3.4 Instrumentation and Control

The information in this section of the reference ABWR DCD, including all subsections, tables, and figures, is incorporated by reference with the following departure.

STD DEP T1 3.4-1 (Figure 3.4a, Figure 3.4b, Figure 3.4c)

Figure 3.4a Safety System Logic and Control (SSLC) Control Interface Diagram

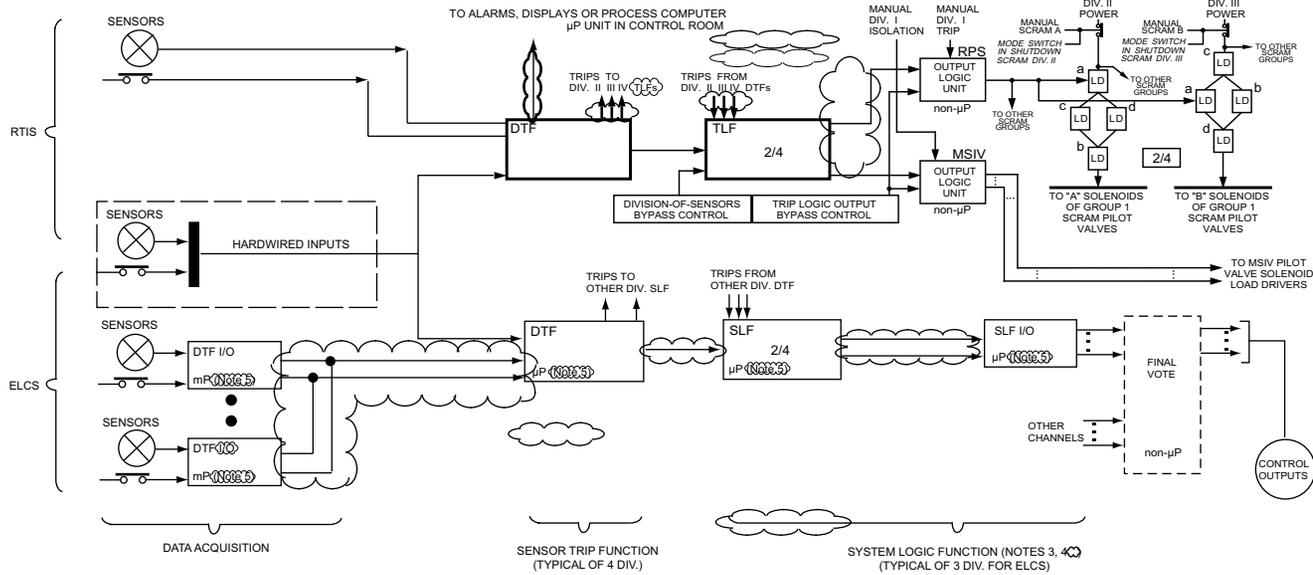
safety-related portions of the Neutron Monitoring System (NMS), the Containment Atmospheric Monitoring System (CAMS) and the radiation monitoring systems. The relationship between SSLC and systems for plant protection is shown in Figure 3.4a.

Figure 3.4b Safety System Logic & Control Block Diagram

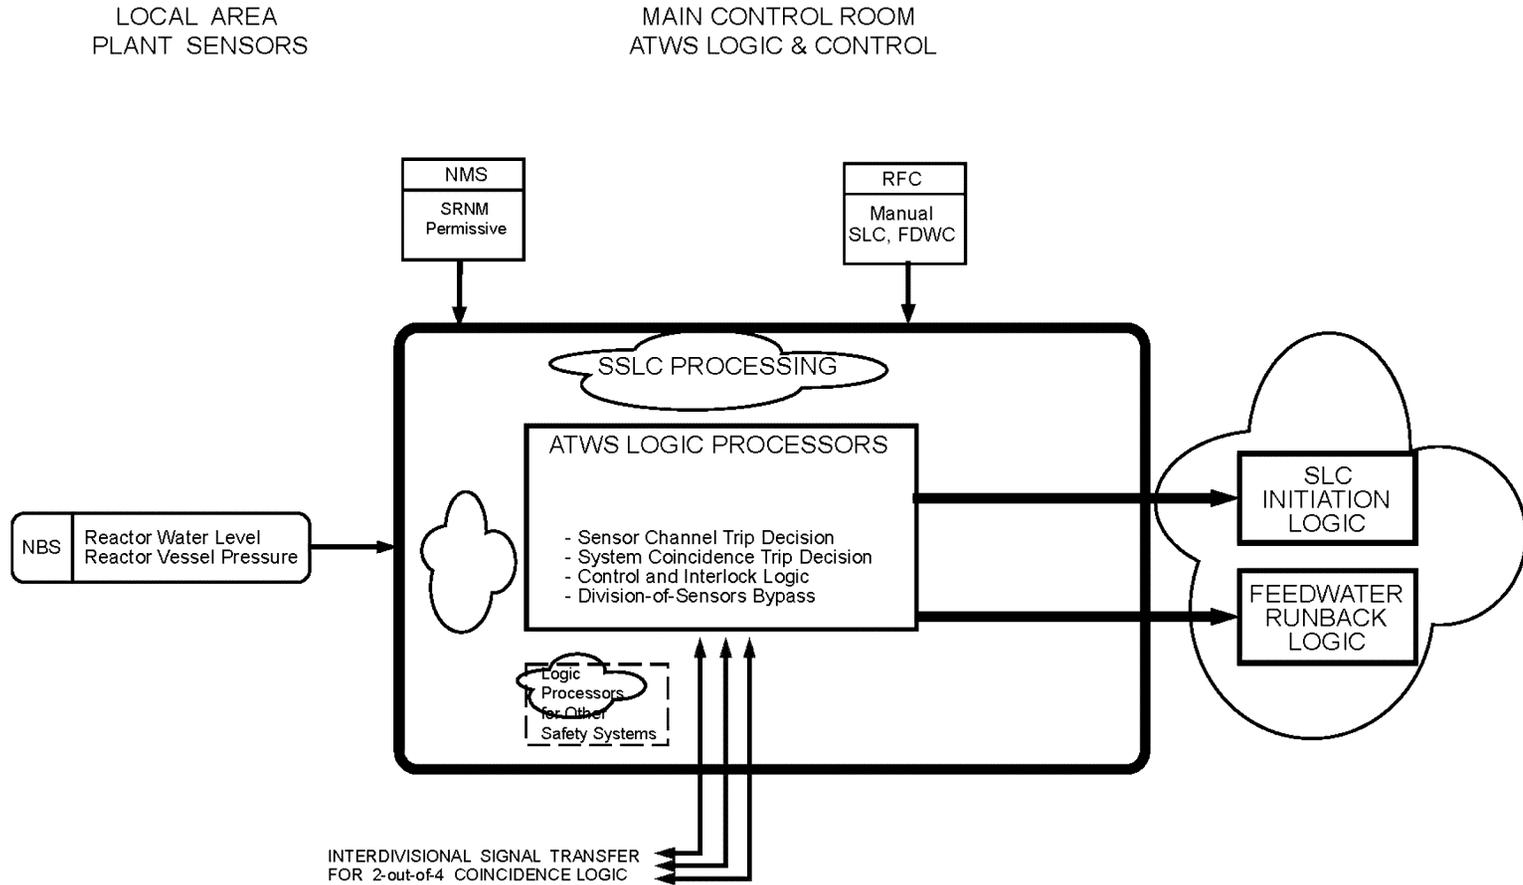
~~The basic hardware functional configuration for one division of SSLC is shown in Figure 3.4b. Each division runs independently (i.e., asynchronously) with respect to the other divisions. The following steps describe the processing sequence and associated function descriptions for incoming sensor signals and outgoing control signals. These steps are performed simultaneously and independently in each of the four divisions:~~

~~As shown in Figure 3.4b, a pair of SLU are located in each of two engineered safety feature (ESF) processing channels, ESF1 and ESF2. ESF1 processes initiation logic for functions which service the reactor vessel at low pressure (e.g. RHR), while ESF2 provides the same support for the vessel at high pressure (e.g. Reactor Core Isolation Cooling (RCIC) System and High Pressure Core Flooder (HPCF) System). Associated LDS and ESF functions are also allocated to these logic channels.~~
